Project 92225.10
27 October 2025
R.001.Rev3
HDS

Geotechnical Review

South Creek West, Sub-Precinct 5, Cobbitty

Report on Suitability Assessment South Creek West, Sub-Precinct 5 621 The Northern Road & 657 The Northern Road, Cobbitty NSW

TITLE: Slope Stability Risk Zone Plan with Proposed Sub-Division Plan Overlay
Geotechnical Review
South Creek West, Sub-Precinct 5
670 The Northern Road, Cobbitty NSW

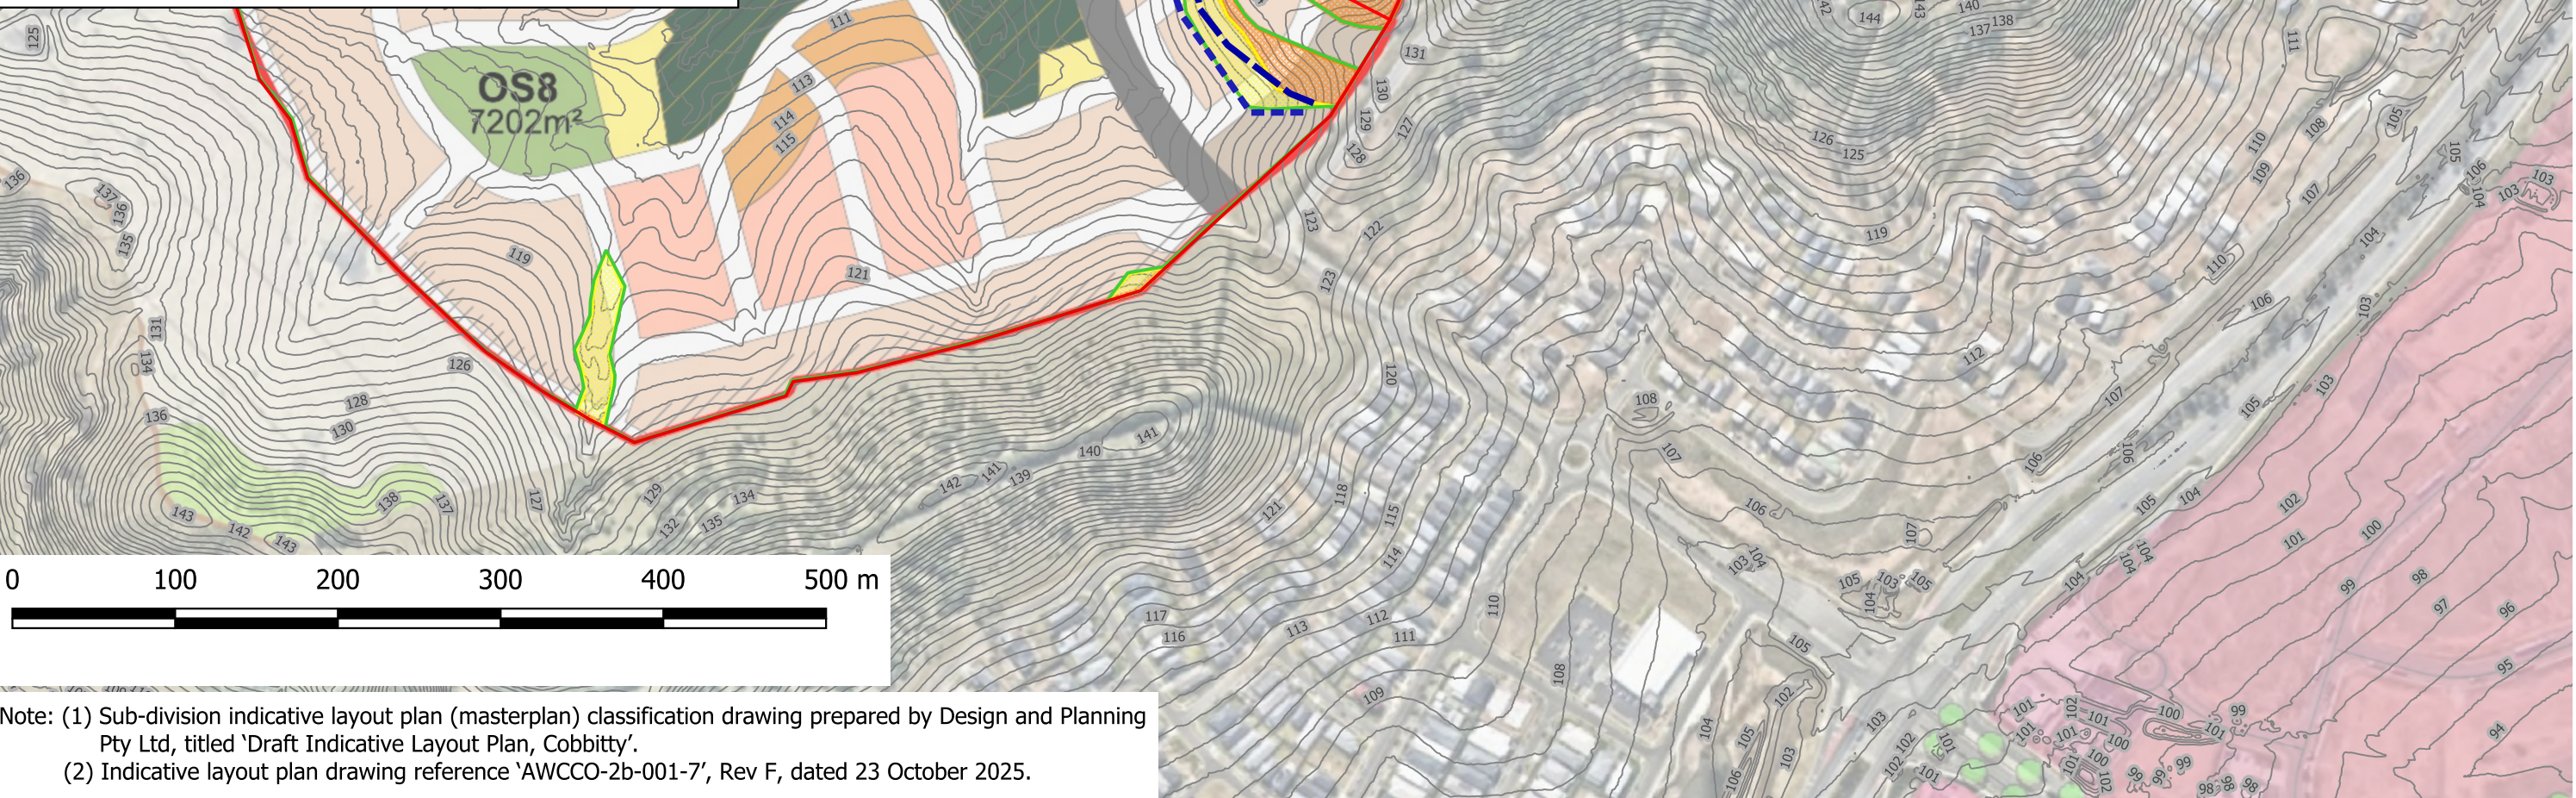
The zones of slope constraints to development near Lot 1 in DP1273487 (i.e. the ridgeline with the water storage reservoirs) are shown together with the revised indicative layout plan on Drawing 1, which includes calculated landslide travel distance runout limits. Downslope boundaries of the three slope constraint zones have been adjusted relative to previous revisions of this report, based on additional site investigation data including further intrusive site investigations and geological mapping.

In a few areas, the calculated landslide runout distance (for 90% of all slides, shown on Drawing 1) extends downslope of the Zone 2 boundary and into areas likely to be nominated for urban building structures and infrastructure. This indicates that earthworks will be required in the upslope Zone 3 areas so that slope instability risks can be mitigated for the proposed urban building envelopes.

- engineering works (such as earthworks and construction of retaining walls) will be required upslope of proposed urban building envelopes in Zone 2 areas (i.e. engineering works needed in Zone 3), to mitigate slope instability risks. There will be significant earthworks and subsurface drainage required as part of rectification of Zone 3. Works in Zone 3 will abut Sydney Water's land and will need to support the Sydney Water land. Douglas recommends early engagement with Sydney Water regarding these works;
